# Road & Bridge Design Publications

## Monthly Update – June 2024

Revisions for the month of **June** are listed and displayed below and will be included in projects submitted for the **October** letting.

SHEET  
 4 OF 8

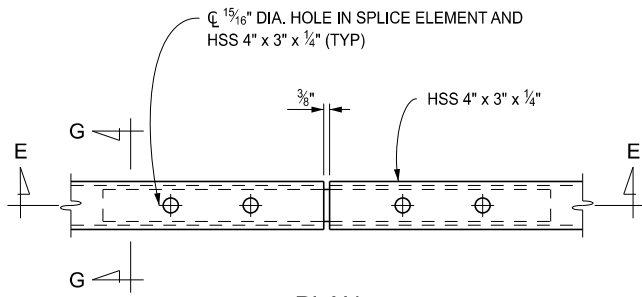
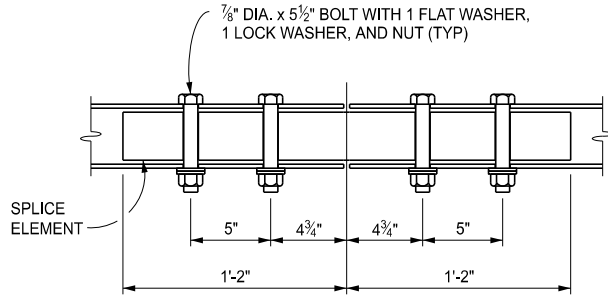
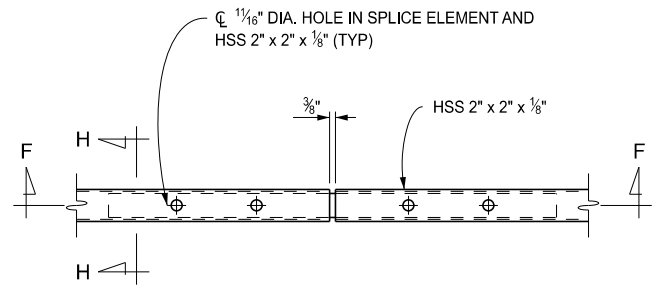
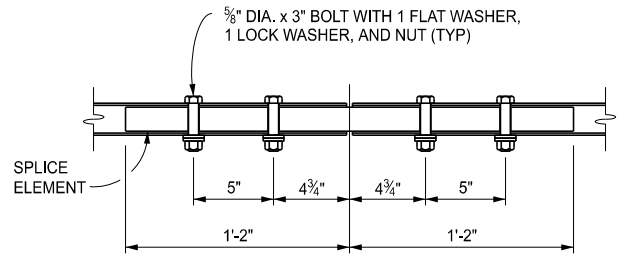
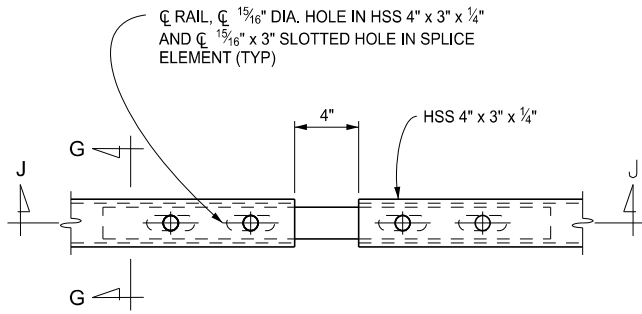
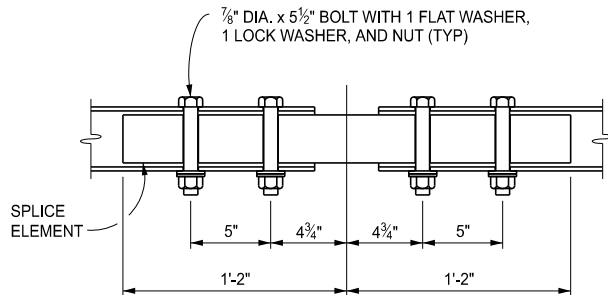
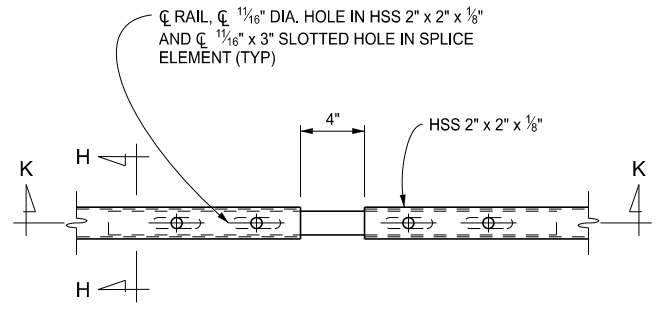
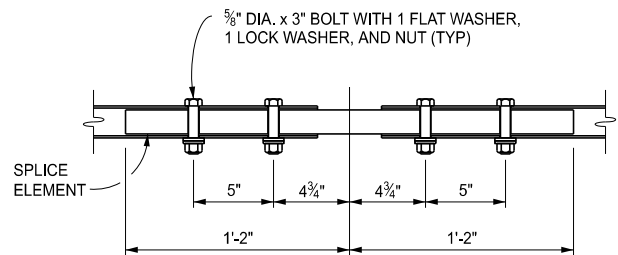
B-25-L: Bridge Railing, Aesthetic Parapet Tube: On sheet 4, decreased the length of the 5/8" slotted round head bolts to 1'- 0 3/4" to reduce the projection past the nut and still allow fabrication tolerances.

CL 1 1/16" x 7/8" SLOTTED HOLE IN RAIL,  
 CL 5/8" Ø x 1'-0 3/4" SLOTTED ROUND  
 HEAD BOLTS WITH HEX. NUT, 1 FLAT  
 WASHER, 1 LOCK WASHER (TYP)

### 6.05.13 (revised 6-24-2024)

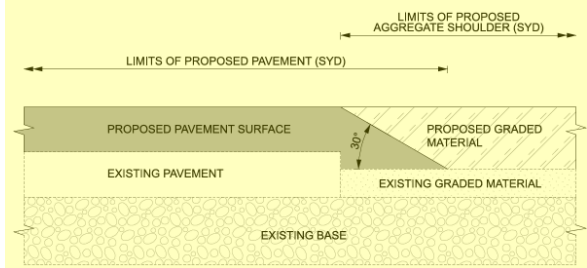
6.05.13: Safety Edge: Updated the detail and added a paragraph to clarify payment for the safety edge when the unit of measure for the pavement surface and/or aggregate shoulder is square yards.

When the proposed pavement surface and/or proposed graded aggregate shoulder uses square yards as units of measurement, the limits of the respective pay item are to the maximum width of placed material, regardless of depth. This can result in overlap on the plan view between the proposed pavement and proposed graded shoulder at the sloped area of the safety edge. There is no deduction in quantities for either pay item at this location to account for the varying depth at the sloped area when using square yards as the unit of measurement.

#### Temporary Support Notes

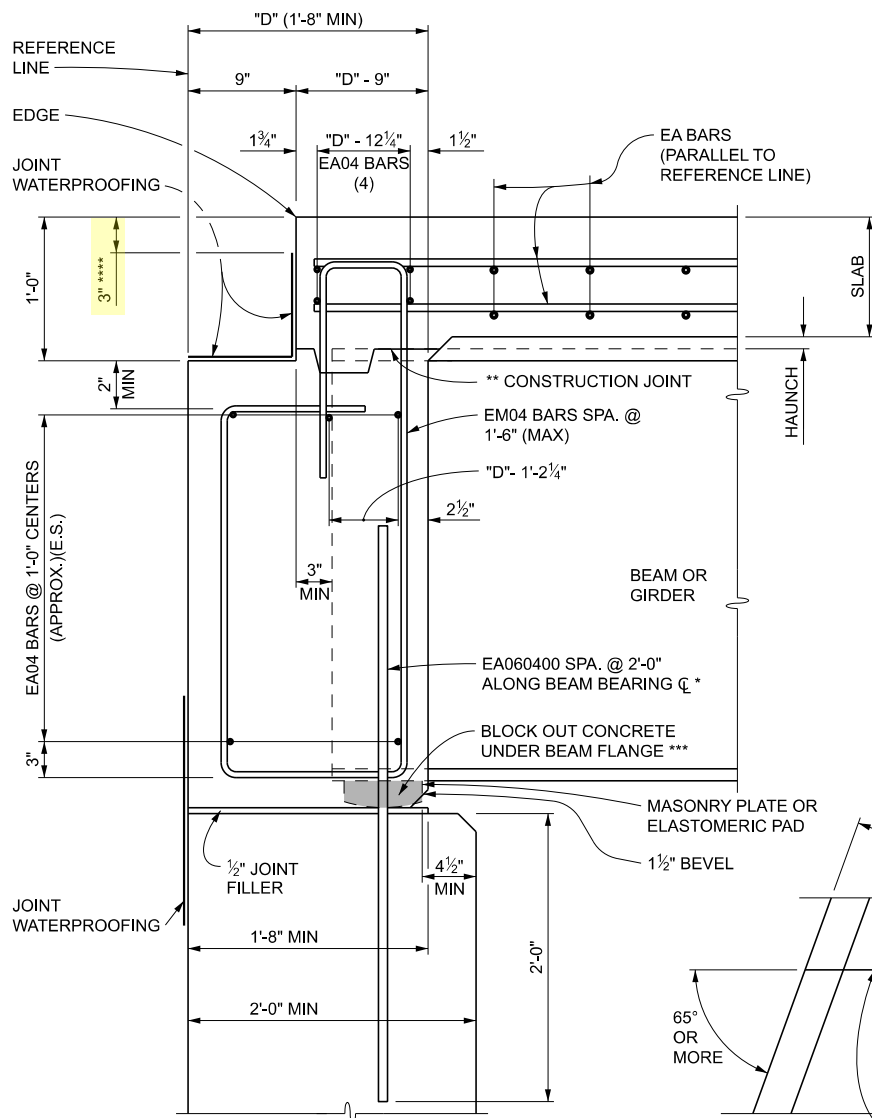
8.09.07: Temporary Support Notes: Added 48 hour notification requirement for temporary support foundation inspection by MDOT Soils Engineer.

- A. Contact the Region Soils Engineer **at least 48 hours in advance** to request a foundation inspection prior to the placement of the temporary support footing (or the "Embankment, Structure, CIP"). **(6-24-2024)**

**6.20.01**

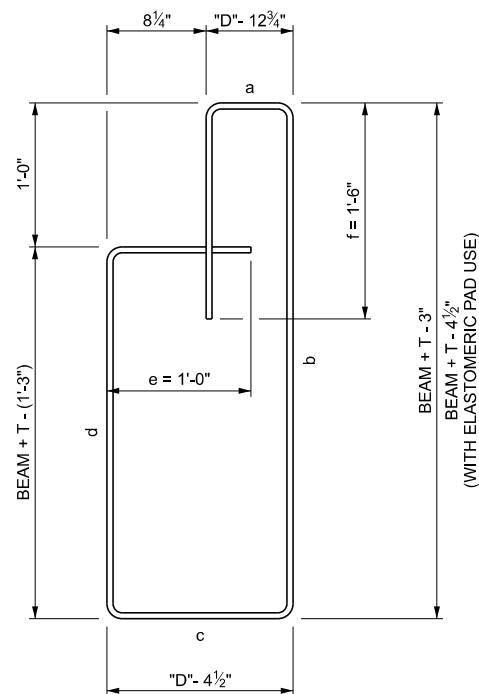
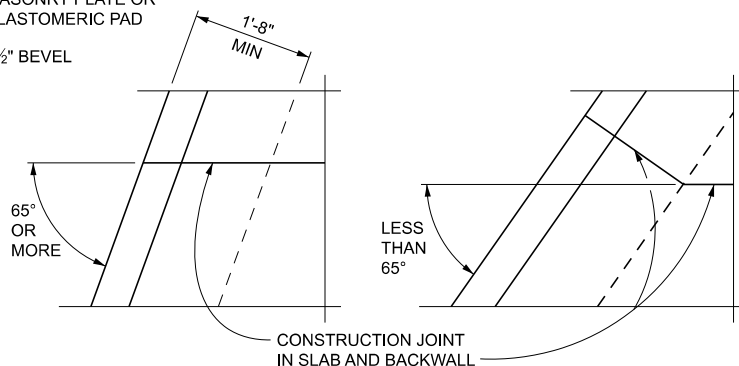
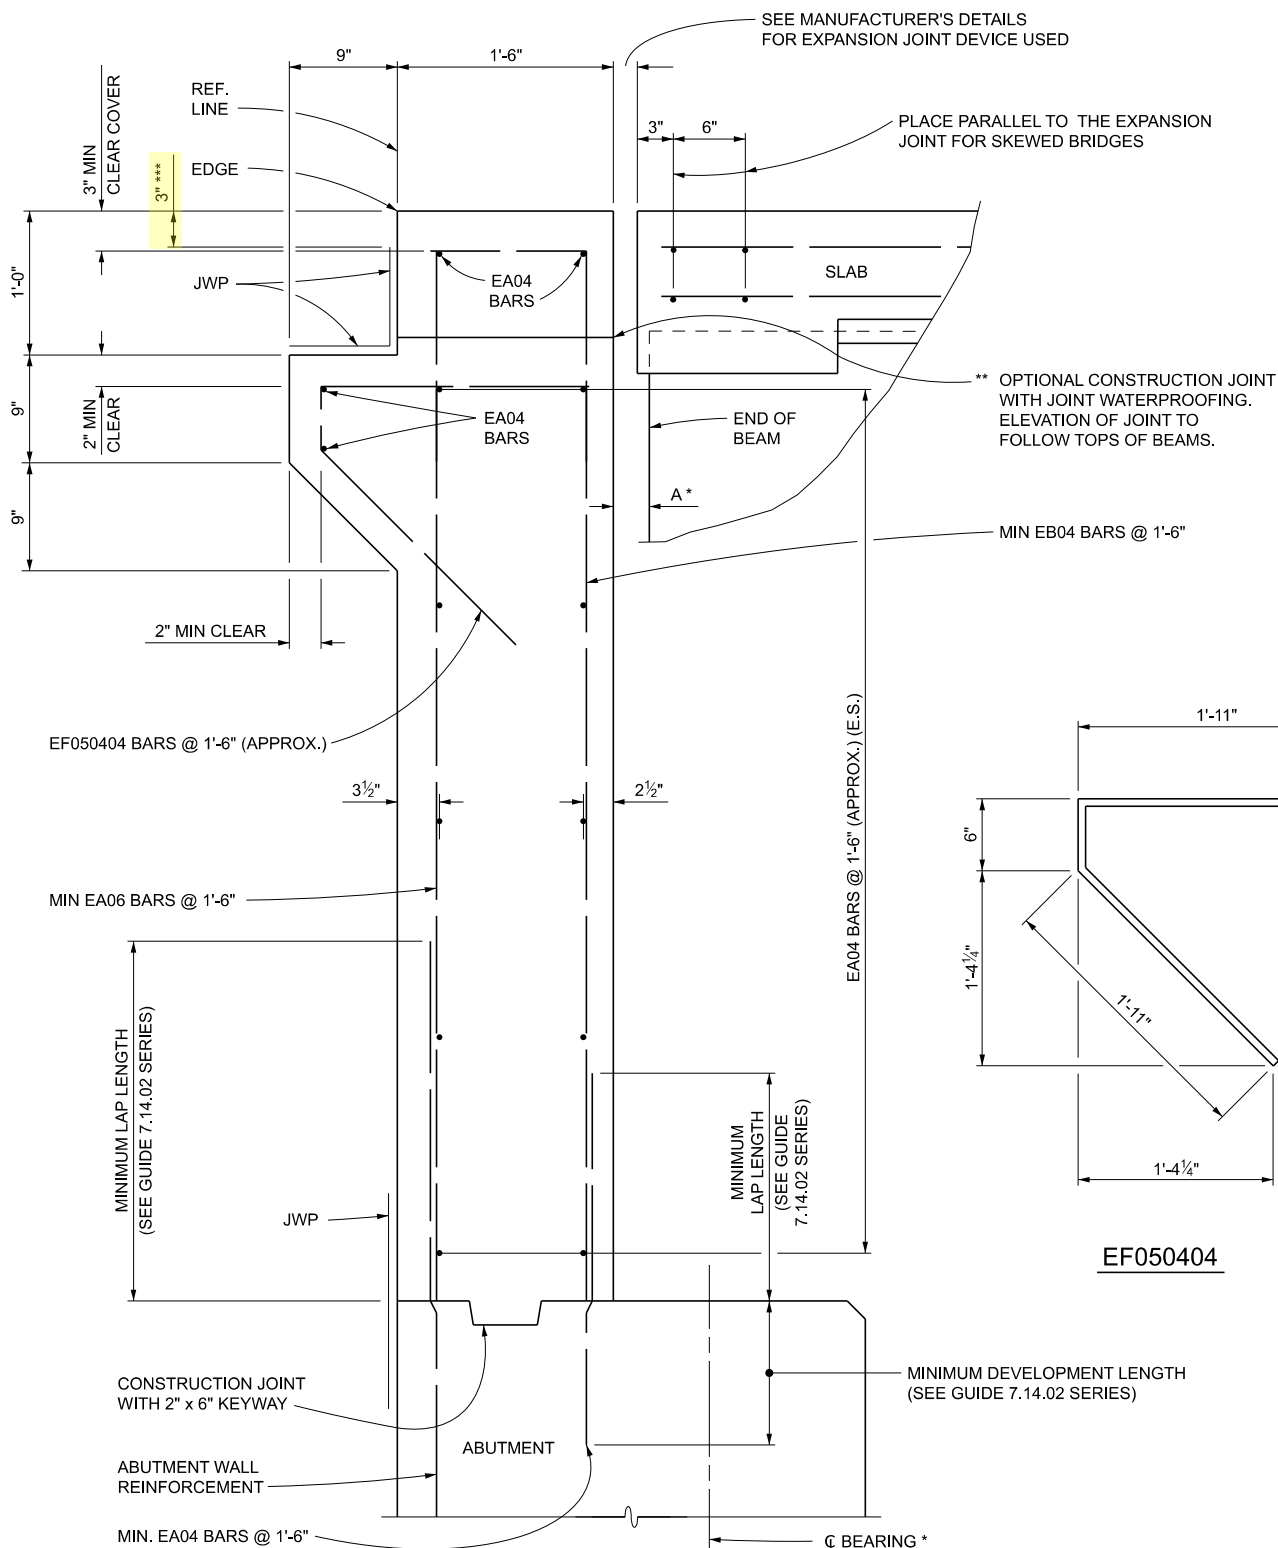
6.20.01: Typical Section thru Dependent Backwall & 6.20.03: Typical Section thru Independent Backwall: Decreased height of joint waterproofing on vertical face of pavement seat by 3" to allow for adhesion of E3 joint or other possible joints.

\*\*\*\* ON THE VERTICAL FACE OF THE PAVEMENT SEAT, STOP THE JOINT WATERPROOFING 3" BELOW THE TOP OF DECK.
